RE-EVALUATION FORM

A. Re-evaluation Type(s): Design Change

Project Name: DISTRICTWIDE TAMPA INTERSTATE IMPROVEMENT STUDY

Figure 2 Reo Street/Kennedy Boulevard Interchange Design Changes

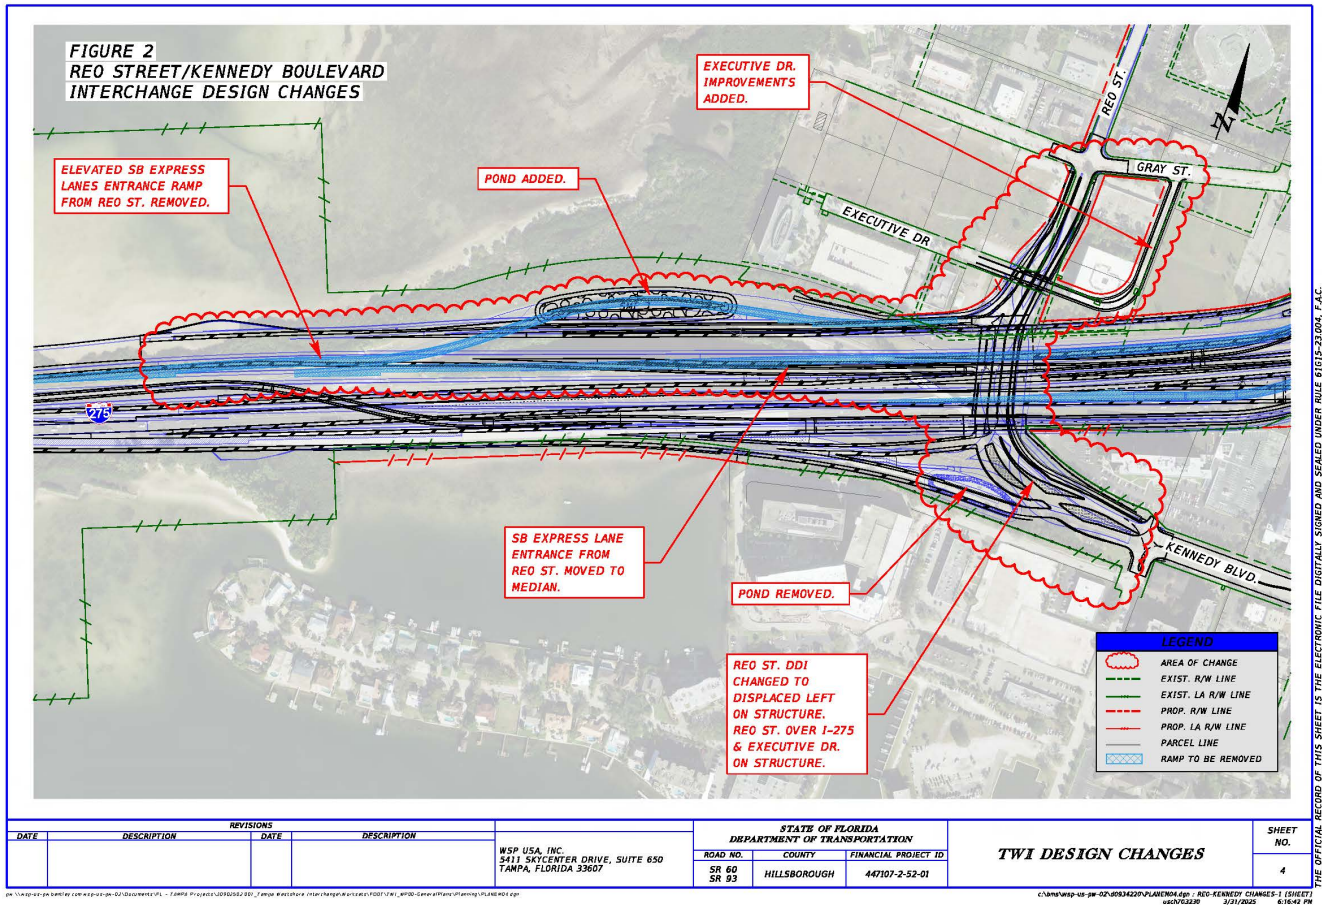
Reo Street is now elevated over the I-275 lanes instead of I-275 being elevated over Reo Street. This allows the I-275 corridor to remain at-grade in this area and allows the Westshore Area interchange to be lower, thereby increasing efficiency of the interchange. The complex braided ramp from Reo Street/Kennedy Boulevard to the southbound I-275 Express Lanes was replaced with a slip ramp in the median of I-275. Access from Executive Drive to Reo Street is provided under the elevated Reo Street via Gray Street, as opposed to at grade from the previous re-evaluation, and construction of a connector road through a previously acquired property. The modifications at the Reo Street/Kennedy Boulevard Interchange also improves safety for bicyclists and pedestrians via improvements to Executive Drive. As part of the interchange modification the proposed pond to the southwest of the Reo Street and I-275 interchange has been relocated. The Reo Street interchange was reconfigured from a Diverging Diamond Interchange to a Displaced Left Turn Interchange. This required a realignment of the I-275 northbound off ramp into the location of the proposed pond. This pond was relocated to north of I-275 to the west of the Reo Street Interchange. The area the pond was relocated to became available with the reconfiguration of the Reo Street interchange. The ramp from Reo Street to the I-275 southbound Express Lanes had occupied this area but with the reconfiguration, it was moved into the median of I-275. The design changes are shown in Figure 2.

Figure 3 I-275 at SR 60 Design Changes

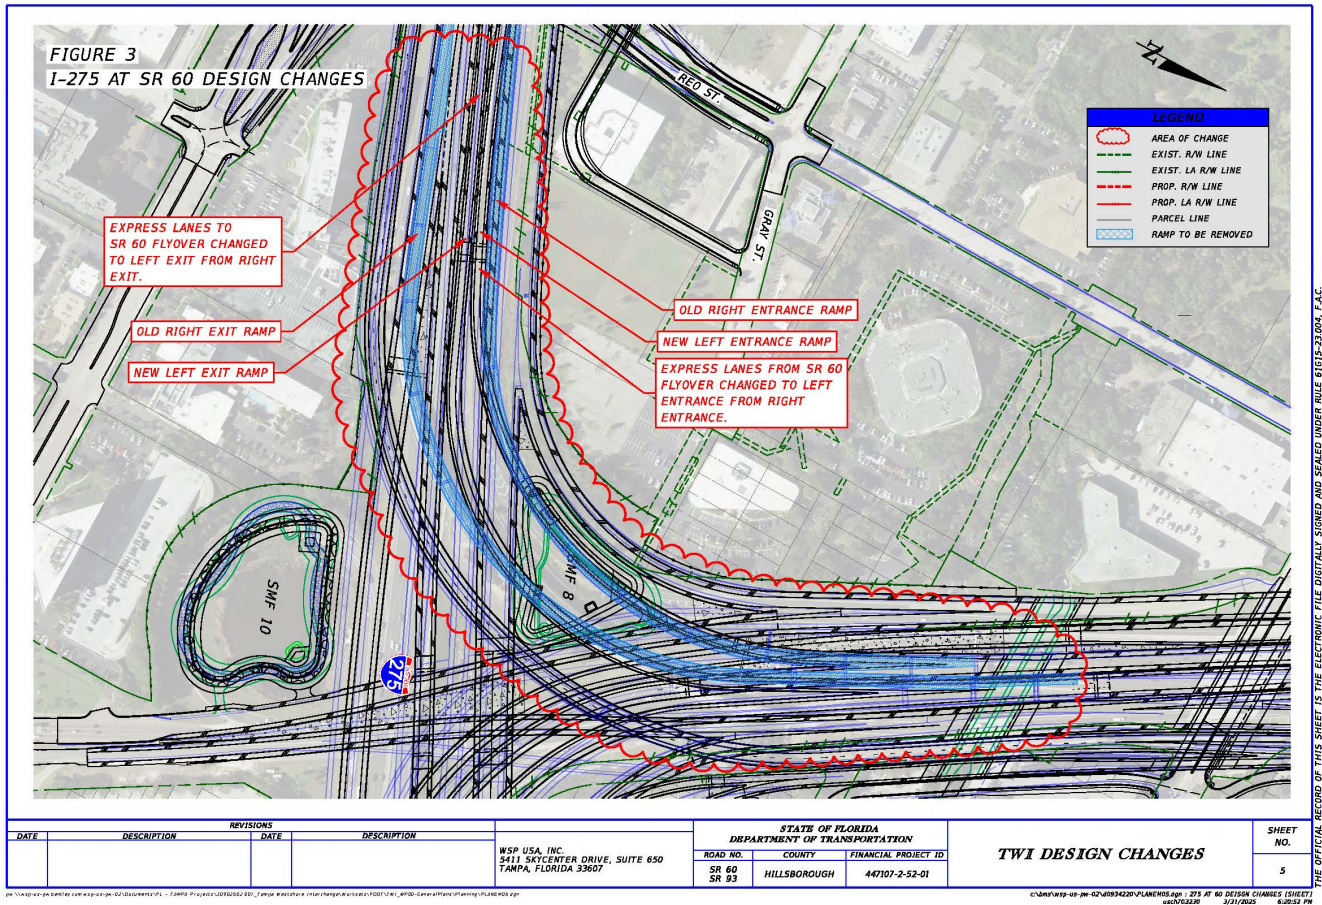
A design change is occurring with the express lane ramps at the I-275 and SR 60 interchange. The design changes include relocating the northbound I-275 to westbound SR 60 express lane exit ramp from the right side to the left side and relocating the eastbound SR 60 to southbound I-275 express lanes entrance ramp from the right side to the left side (Figure 3).
